UNITED STATES
NUCLEAR REGULATORY COMMISSION
REGION IV
611 RYAN PLAZA DRIVE, SUITE 400
ARLINGTON, TEXAS 76011-4005

EA 07-090

SUBJECT: FINAL SIGNIFICANCE DETERMINATION FOR A WHITE FINDING AND NOTICE OF VIOLATION - NRC SPECIAL INSPECTION REPORT 05000298/2007007 - COOPER NUCLEAR STATION

Figure A-1 CNS PRA Event Tree Modifications

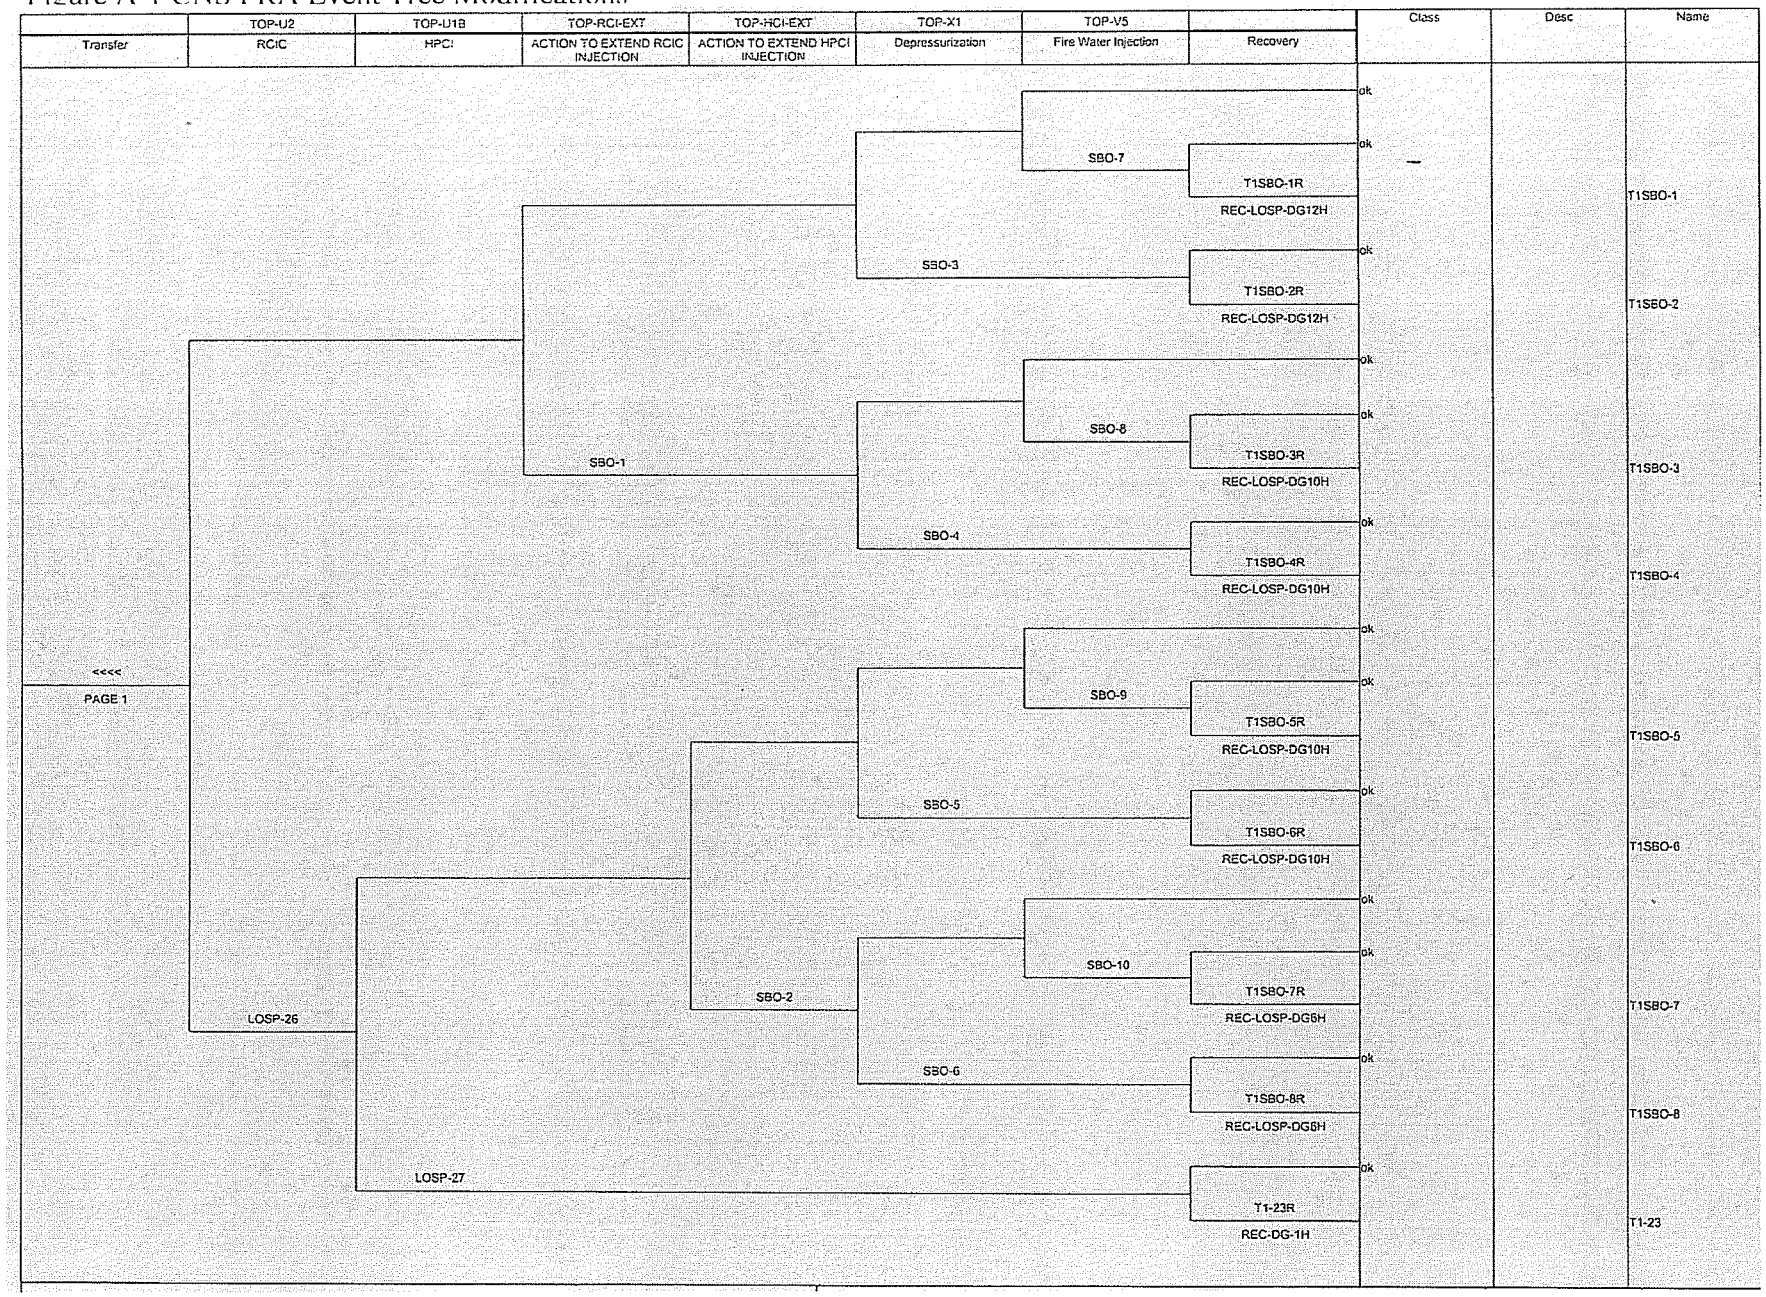
The Station Black-out (SBO) portion of the CNS Loss of Offsite Power (LOOP) event tree was modified to reflect updated timing insights gained through thermal hydraulic and battery depletion calculations performed to support the PRA upgrade project. Of particular importance to SBO mitigation are timing for potential challenges to high pressure injection systems (HPCI and RCIC) and individual battery depletion timing (with and without load shed). The revised LOOP event tree considers updated information regarding:

1) Battery depletion timing for each DC bus,
2) Potential RPV low pressure isolation challenges due to operator actions to emergency depressurize the RPV in response to EOP required actions on Heat Capacity Temperature Limit (HCTL), Pressure Suppression Pressure (PSP), and high drywell temperature,
3) Potential equipment trips due to high exhaust back pressure,
4) Potential suction source impacts associated with ECST depletion or suction temperature if automatic suction swap to the suppression pool is anticipated, and
5) Post event room heat-up impacts on equipment reliability.

Use of the on-site diesel driven fire pump was added to the event tree for potential credit provided initial success of HPCI or RCIC, but was given a failure probability of 1.0 for this study.

Figure A-1 shows a graphical representation of the revised LOOP event tree. The new core damage sequences are named T1SBO-1 through T1SBO-8 and are described as follows:

Figure A-2 SPAR Model Event Tree Modifications

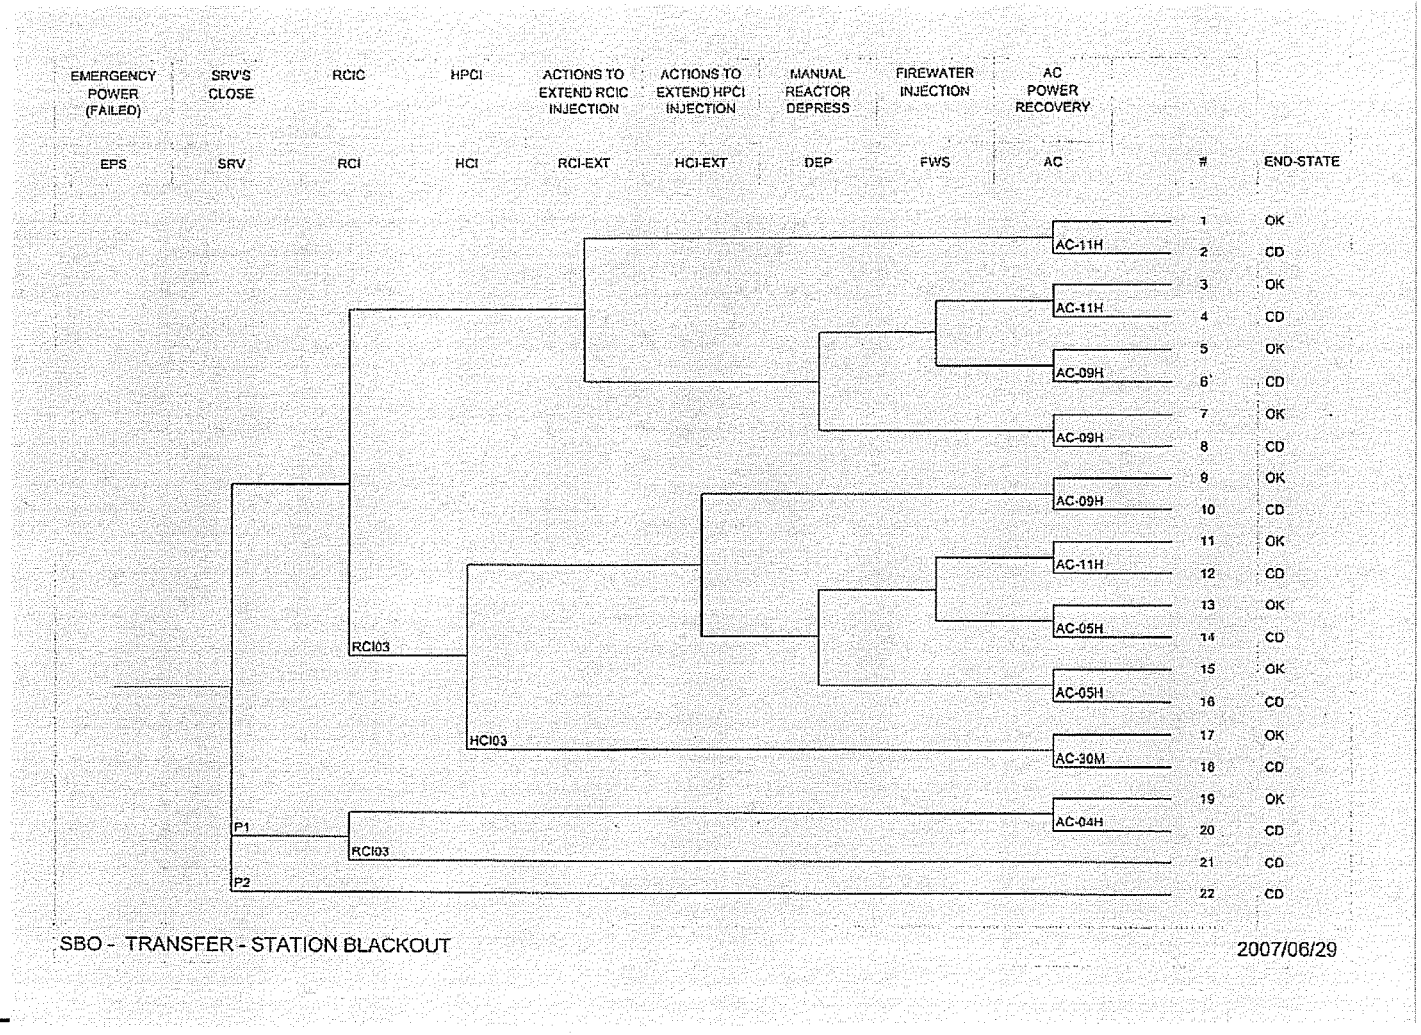
The SBO event tree in SPAR was also adjusted to reflect the need to better reflect battery depletion times and both the ability to extend HPCI and RCIC mission times. Figure A-2 represents the adjusted SPAR SBO tree. Specifically, a node was added to reflect the ability of specific actions to extend HPCI mission time and the AC power recoveries were adjusted to reflect the additional recovery time available when using the extended battery depletion times. The event tree does not reflect extended boil off times available to restore AC power prior to core damage.
